TOWN OF NISKAYUNA
Planning Board and Zoning Commission
Agenda
April 11, 2022
7:00 PM

AGENDA STATEMENT

ITEM TITLE: DISCUSSION: 3713 State Street – Goodyear Tire Store – site plan application for placement of a 20' long x 8' wide storage container on the property

ITEM TITLE: DISCUSSION: 2341 Nott St. – St. James Plaza – site plan application for placement of a Chase Bank ATM in a portion of the Shop Rite parking lot.

A102

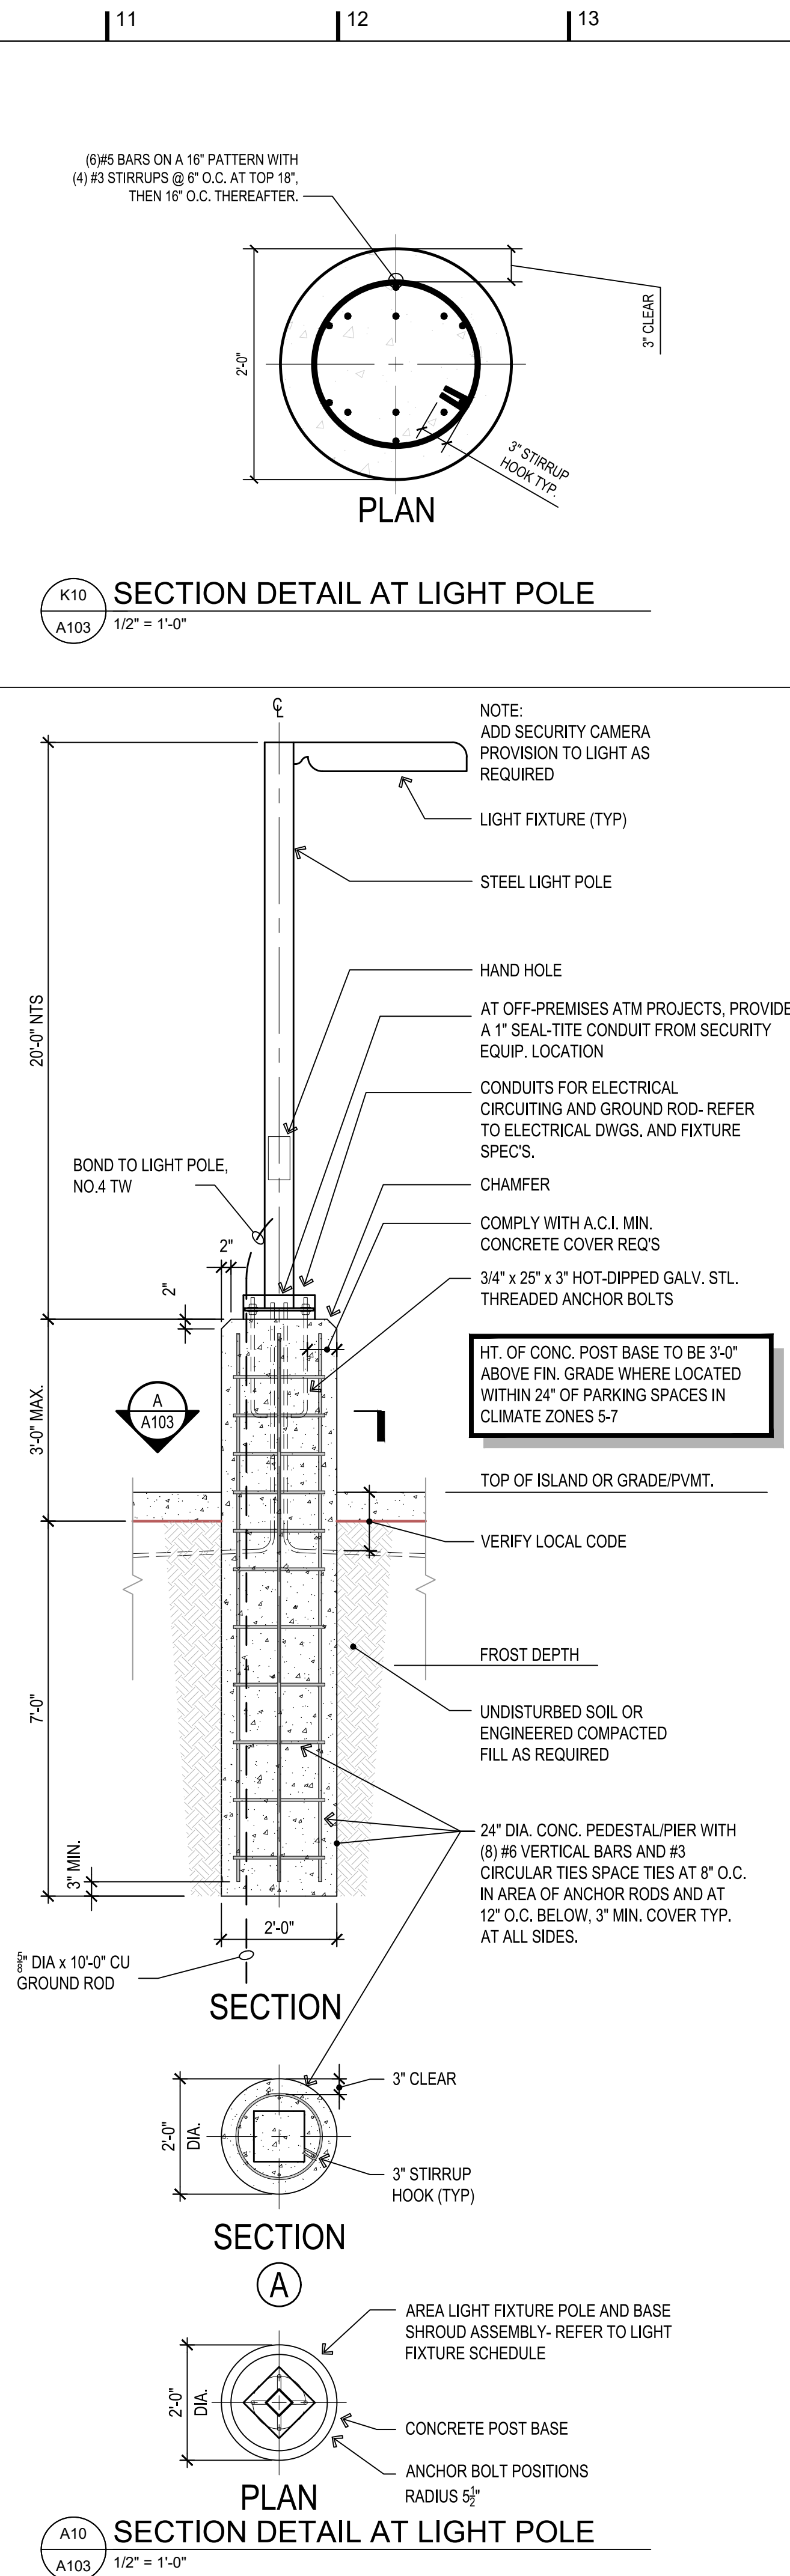
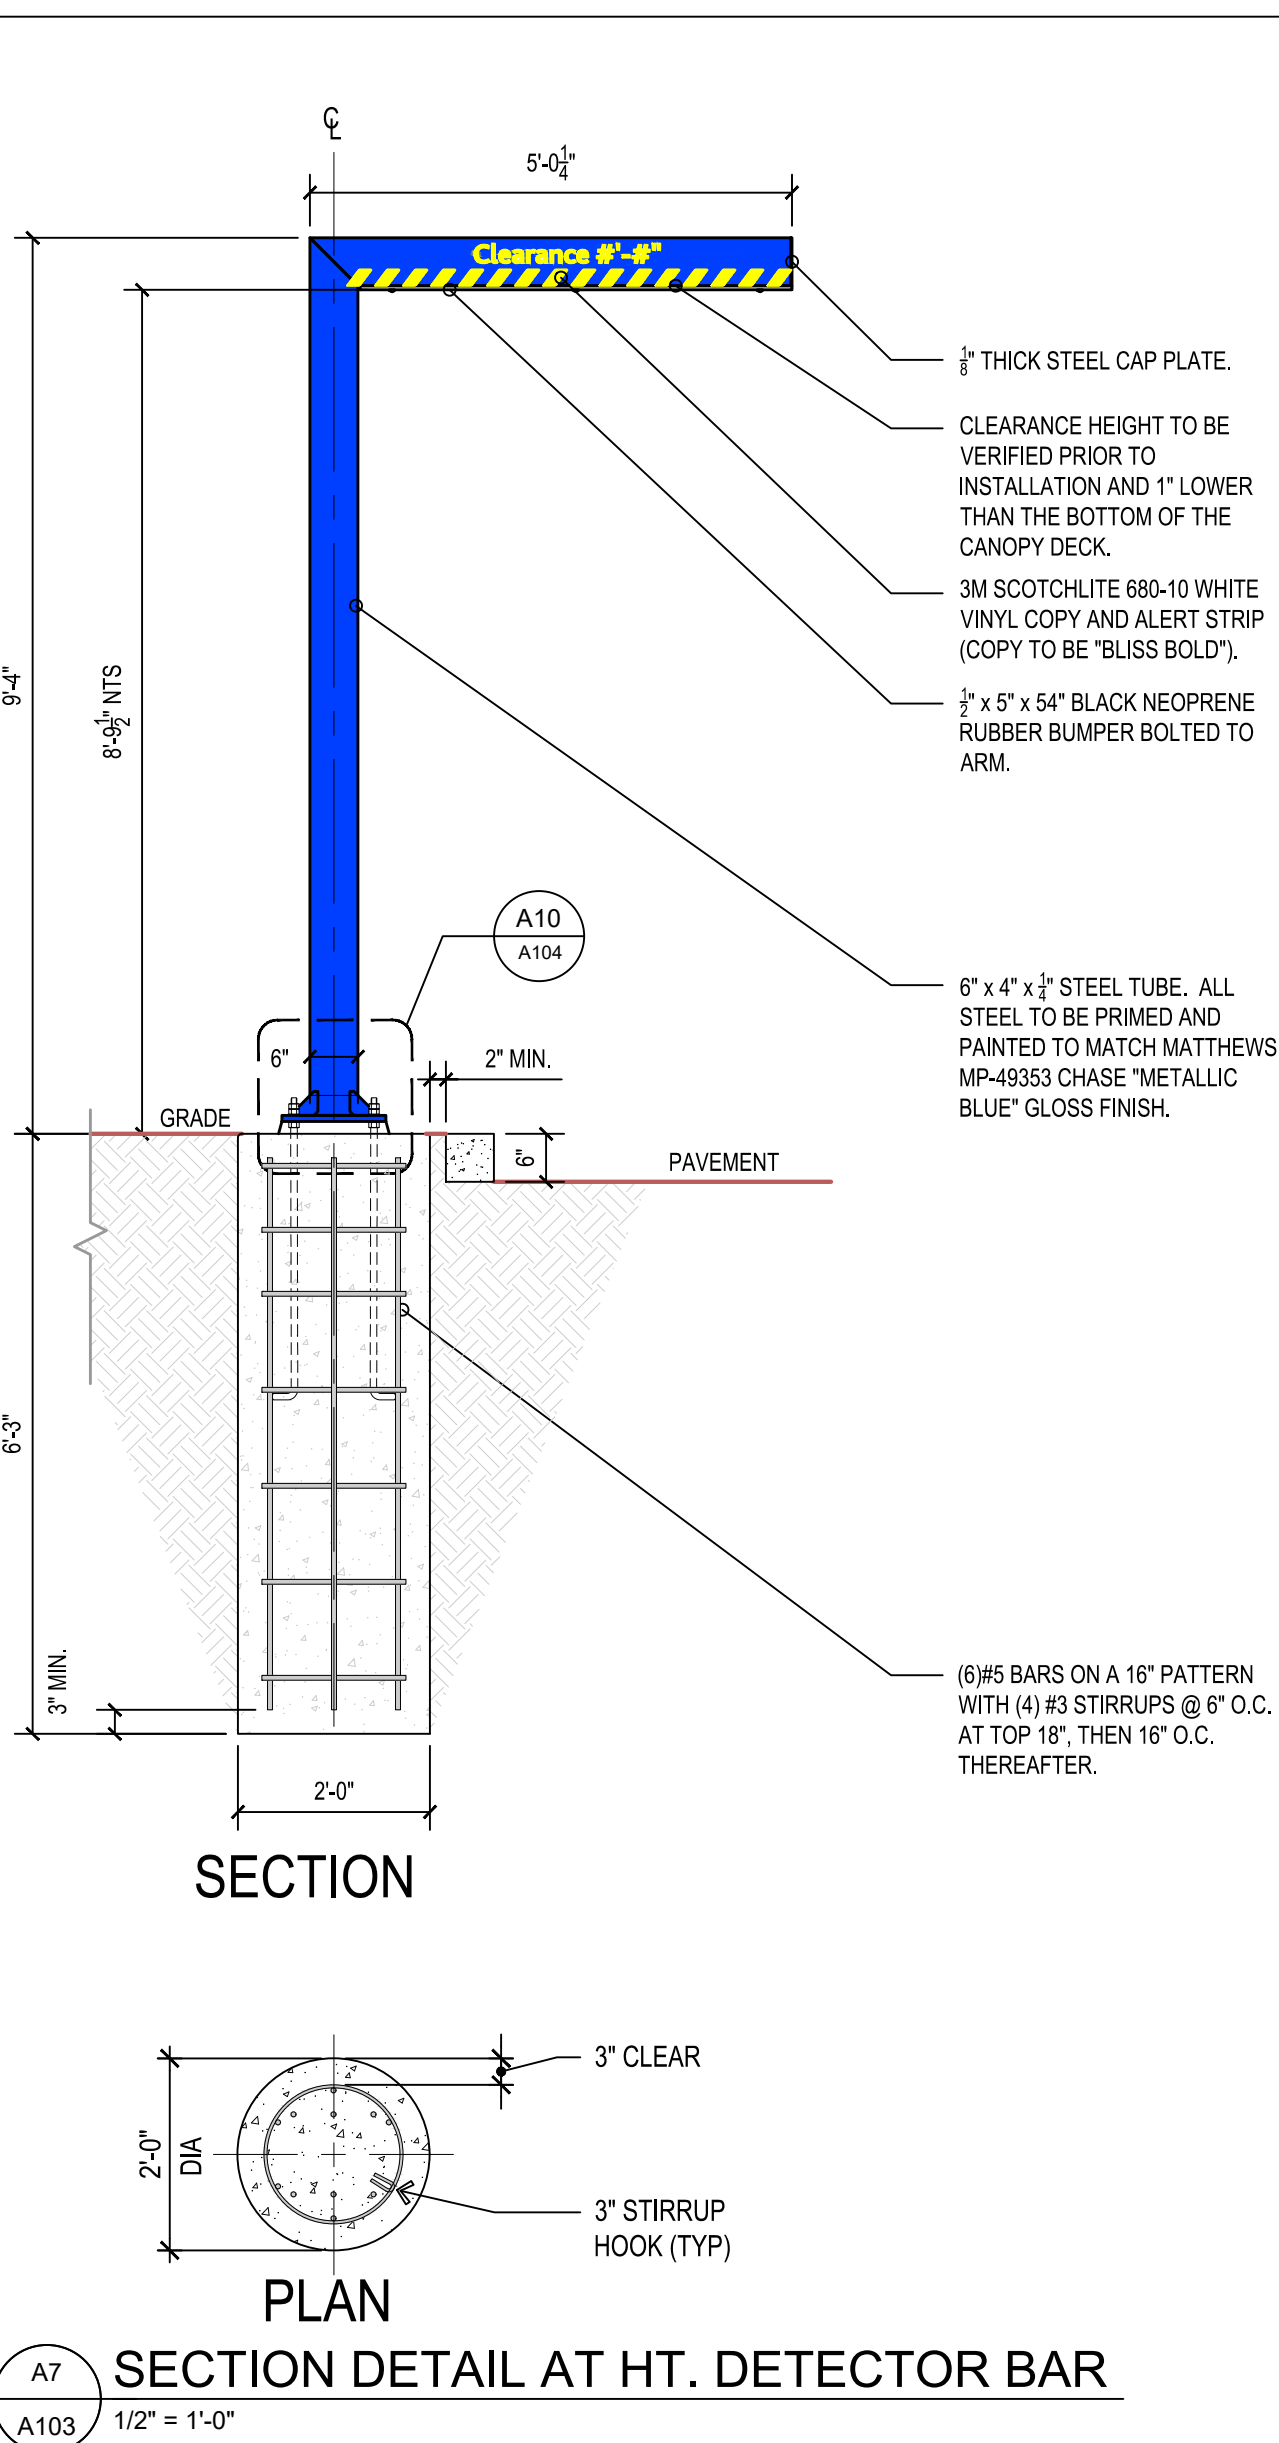
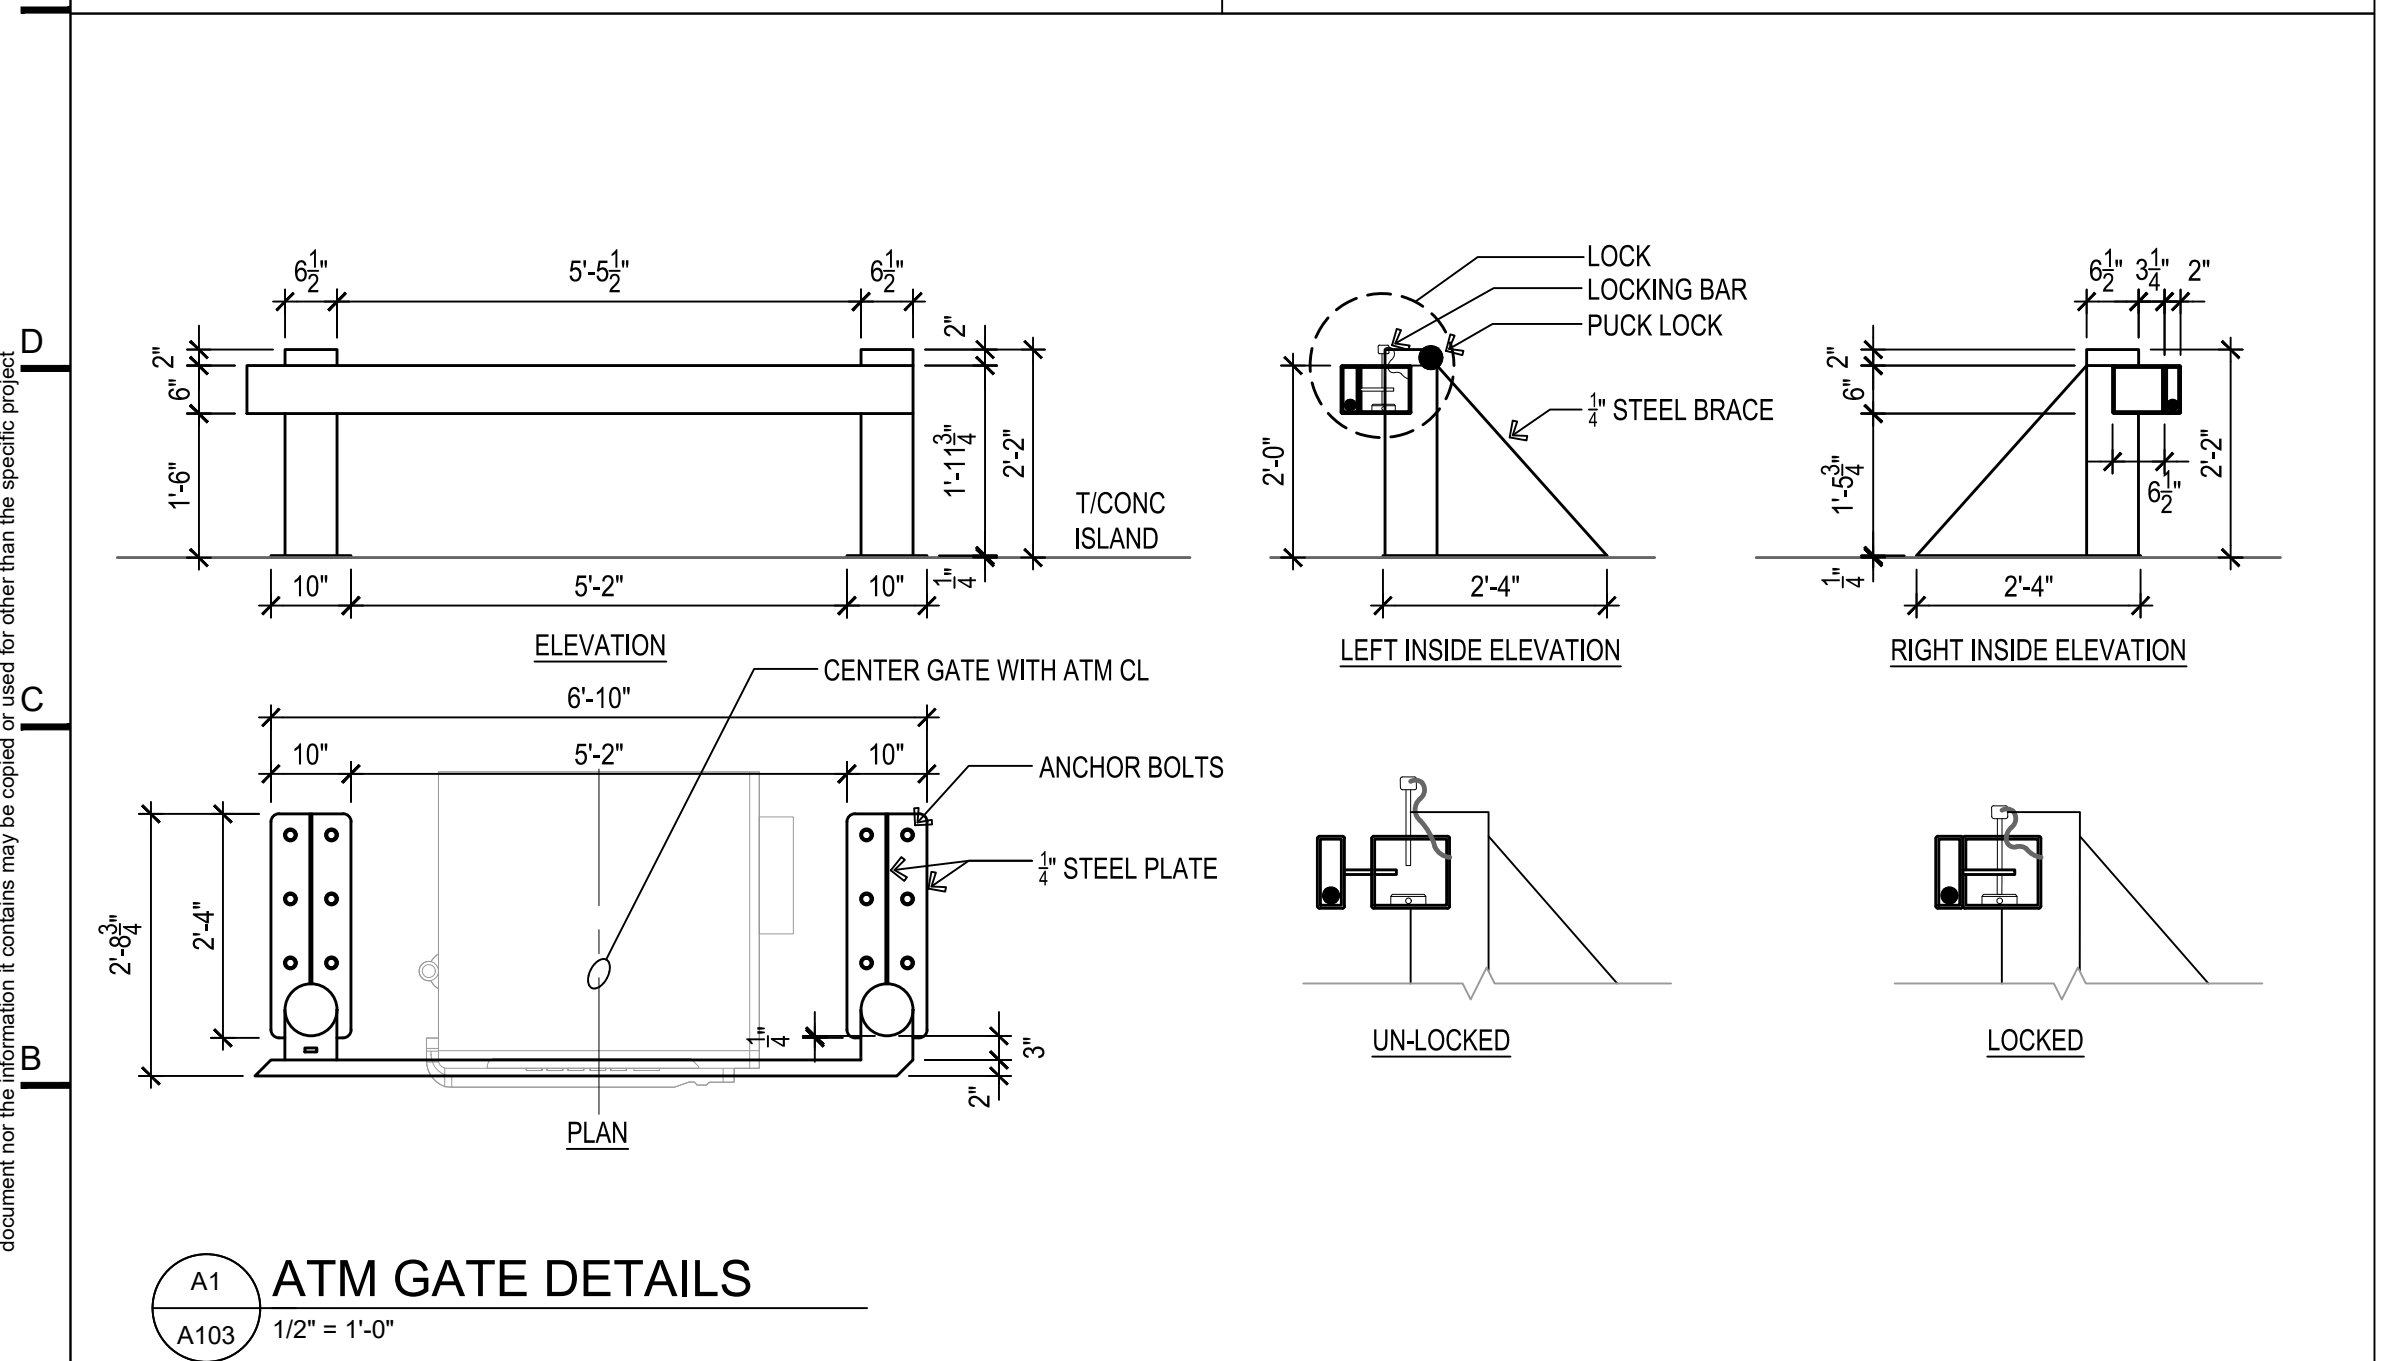
As proposed, page A102 of the drawing set includes a light pole with an area light measuring 23’ high (3’ high concrete base + 20’ high light pole) located at the entrance to the ATM machine. Therefore, a waiver of 1’ (23 – 22) of pole height from finished grade is required.

Pages A102, A103 and A104 of the aforementioned drawing set include design details for the proposed ATM. Several portions of the ATM station infrastructure and associated graphical displays should be reviewed by the Board relative to the requirements set forth in Section 220-4 of the zoning code. The drawings include a "non-illuminated signage option" that reads "CHASE" followed by the Chase Bank logo on one of the canopy legs.
